# PROPOSAL REQUEST

Project Name:	<b>Haverhill Consentino Middle School</b>	PR No.	<b>02</b>
Architect's Project No.	<b>21-0818</b>		
Owner:	<b>City of Haverhill 4 Summer Street Haverhill, MA 01830</b>	Architect:	<b>DORE + WHITTIER 260 Merrimac St, Bldg 7, Newburyport, MA 01950</b>
To:	<b>Brait Builders Corporation 57 Rockwood Road Marshfield, MA 02050</b>	Contract Date	<b>4/1/2024</b>
		Issue Date:	<b>7/25/2024</b>
Attention:	<b>TJ Dahill</b>	Subject:	<b>Expansion Tank Size-Submittal</b>

To coordinate with Expansion Tank Bladder size changes made in 23 00 10 – 006 Air Separators, Automatic Air Vents, and Expansion Tanks, revise the following:

### Bell & Gossett Model: R-8F

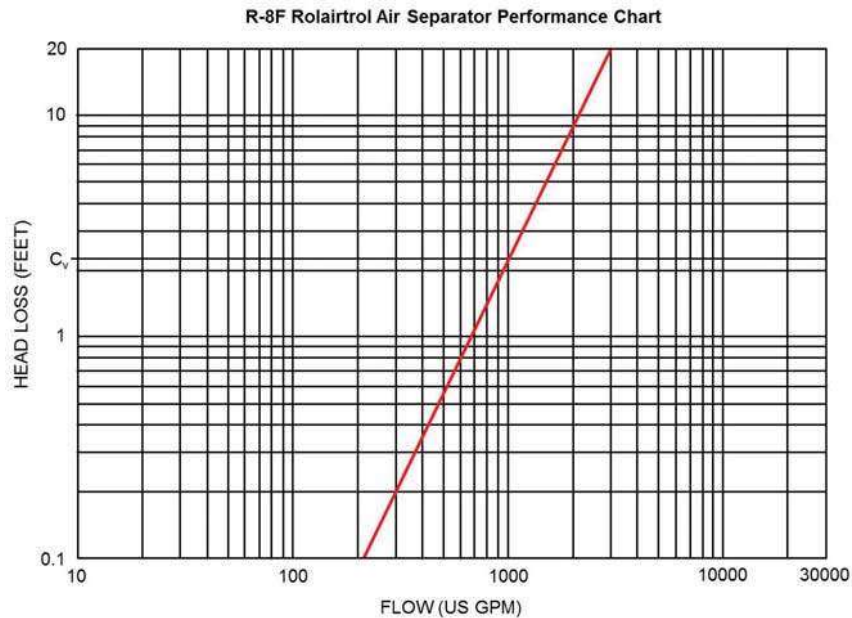
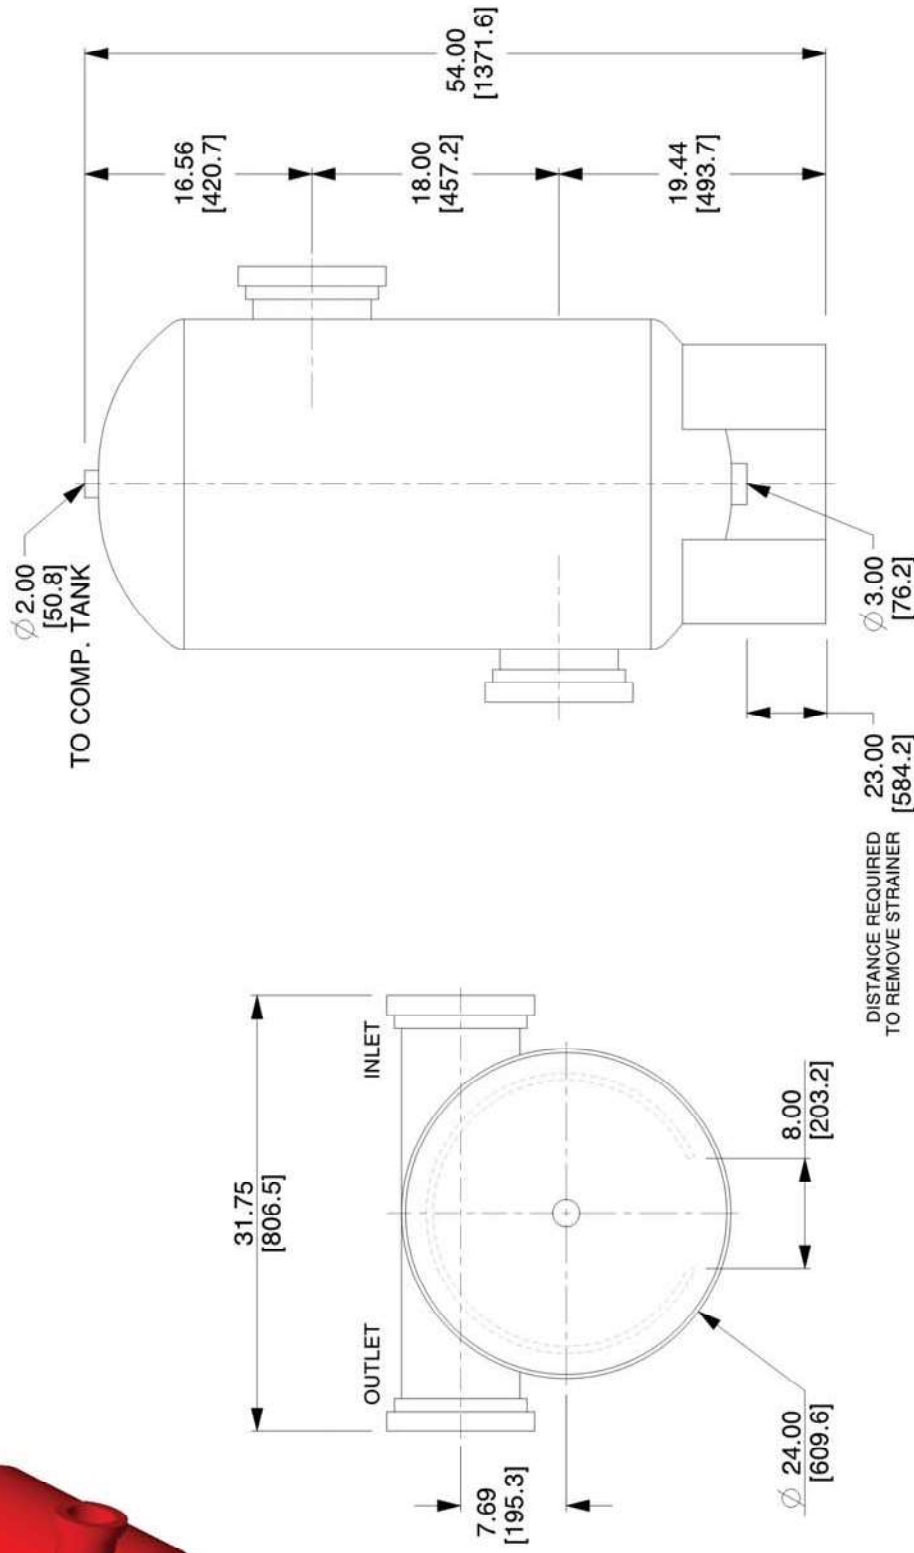
1. ET-1 serving HHW system shall be model B1400.
2. ET-2 serving CHW system shall be model B600.
3. Mechanical Contractor shall set system pressure per Expansion Tank schedule on drawing M0.06.
4. AS-1 serving HHW system shall be model R-10F.

- 2. Resubmitting on air separators less strainers per discussion with engineer.**
- 3. Expansion tank sizes revised per submittal comments.**

AS-1 serving HHW system shall be modified to model **R-10F**.
